Memorandum

To: K Lynn Berry, Superintendent, John Muir National Historic Site (JOMU)

Subject: Reconnaissance-level evaluation of Strentzel Creek area development plans with follow-up flood risk modeling, JOMU

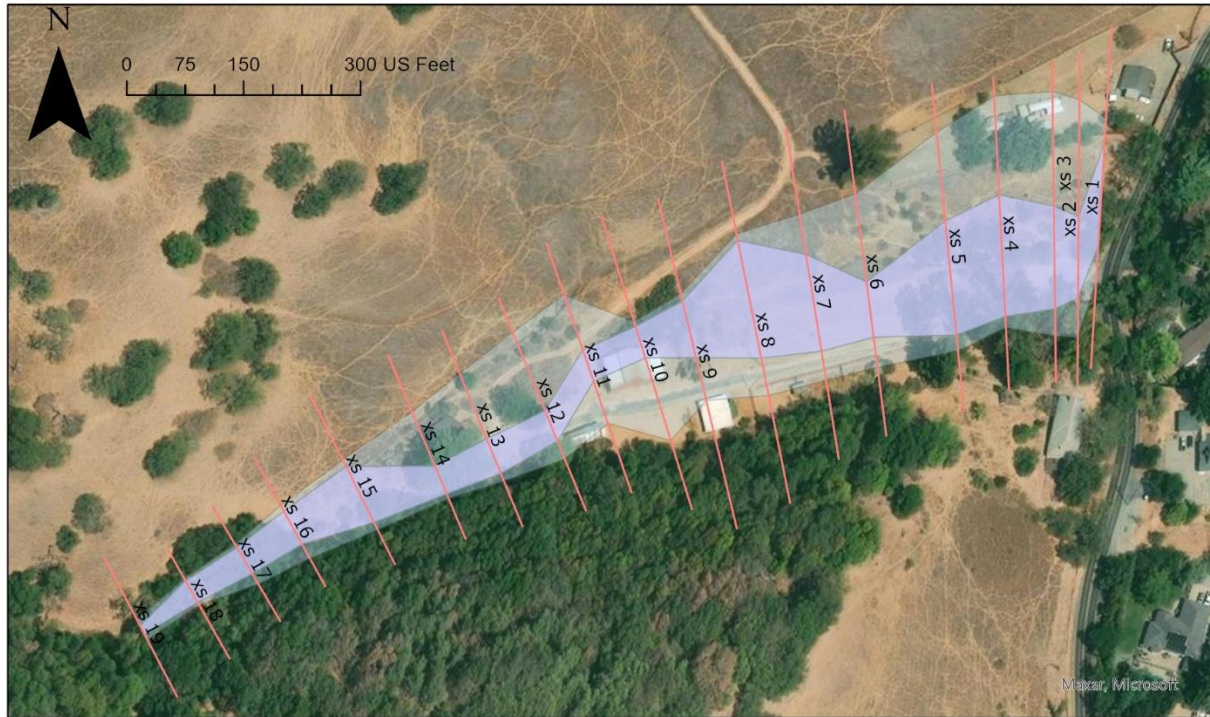
It appears that the southern portion of the fan is less prone to flooding and may provide some non-floodplain locations for development. The proposed hillside location for the Environmental Education Center is well above the modeled Regulatory Floodplain (Figure 1).

When possible, all infrastructure should be located outside of the modeled Regulatory Floodplain (darker polygon in Figure 1). When this is not practicable, site selection should consider flood depths and velocities and design appropriate mitigation up to the level of the Regulatory Flood. Mitigation may include (but is not limited to) robust construction, flow-through or flow-over design, adding fill, etc. In the case of relatively low capital investment, determining the infrastructure as sacrificial is an acceptable mitigation.

Overall flood hazard varies with position on the fan. The upstream edge of the fan is most susceptible to destructive flows, sediment deposition, and channel avulsion, and this is the area where the greatest risk to human health and infrastructure exists. Placing the proposed gathering circle farther eastward and tucked against the shaded southern valley edge and the highest ground available would mitigate flood risk and its obstruction of flow.
